FIRE SAFETY INSPECTION REPORT

KADENA SPORTSWEAR

**STANDARD FACTORY BUILDING NO. 5 & PLOT NO.
113-121**

March 14, 2015

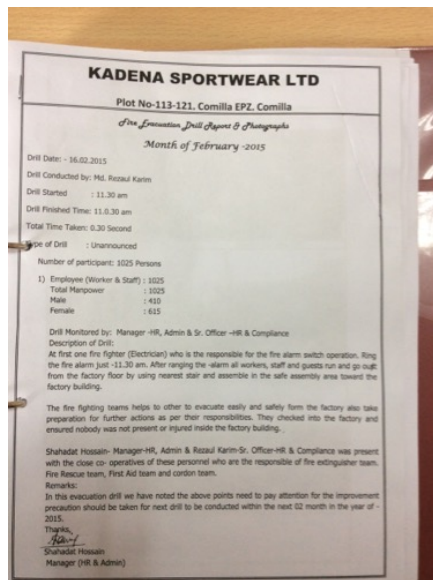
F-5	Fire Rated Construction	The exit discharge path serving the west exit is less than 3 m (10 ft.) wide and is not separated from the building interior.	Seal all penetrations and openings to the interior of the building along the discharge path, up to a height of 10 ft., to provide a minimum 1-hr fire separation.	Within 6 months
-----	-------------------------	---	---	-----------------

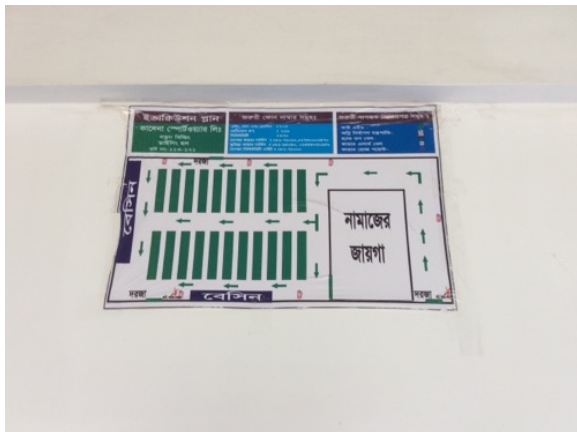
Exit capacity (146) is not adequate for the occupant load (350) on the rooftop during lunch time.

Reduce occupant load immediately to not more than available exit capacity (146) during lunch time. Provide additional exits in the future to increase exit capacity.

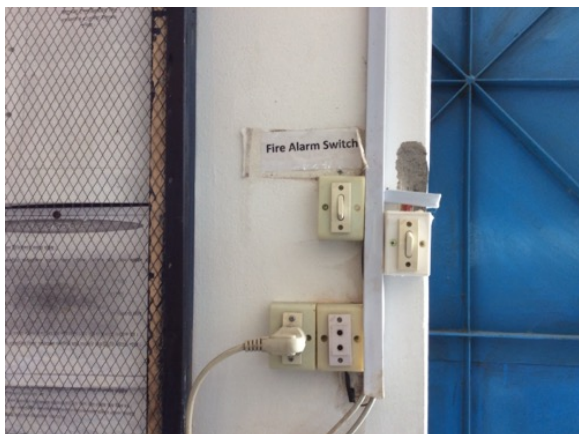
F-15	Fire Protection	The fire alarm system is antiquated, not a listed system and does not provide alarm and notification features consistent with acceptable standards.	Replace the fire alarm system with a new, listed addressable fire alarm system in accordance with NFPA 72.	Design within 4 months, install within 9 months
------	-----------------	---	--	---

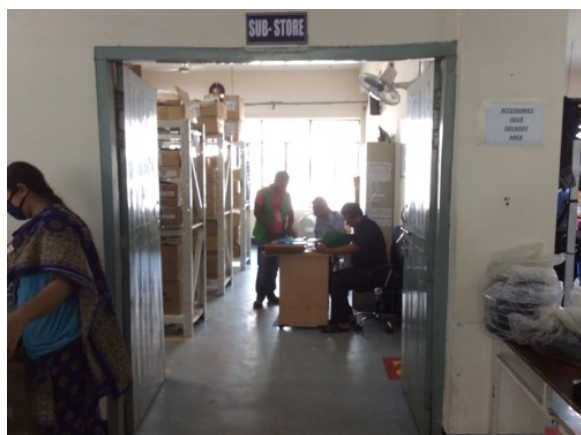
F-7	Fire Rated Construction	Rooms used for combustible storage are not separated by fire-rated construction on first and ground floors.	Provide dedicated storage rooms separated by minimum 1-hr fire-rated construction. Where separate storage rooms are not feasible, provide defined storage areas and limit the storage arrangement as follows: - Maximum height of 2.45m (8ft.) and maximum area of 23m² (250 ft²) - If sprinkler protected: maximum height of 3.66m (12ft.) and maximum area of 93m² (305ft²) Separate areas of unenclosed combustible storage by a minimum clear distance of 3m (10ft.).	Within 3 months
-----	-------------------------	---	---	-----------------

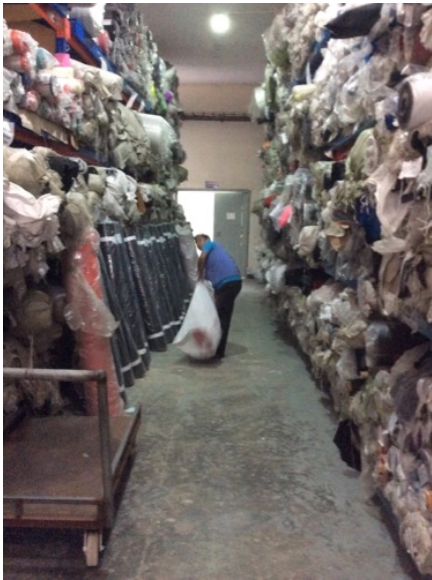
F-16	Egress	Common path of egress travel exceeds limit on the ground floor.	Reconfigure the egress arrangement to reduce the maximum common path of travel to not more than 23 m (75 ft.) or 30 m (100 ft.) when complete sprinkler protection is provided.	Within 3 months
------	--------	---	---	-----------------
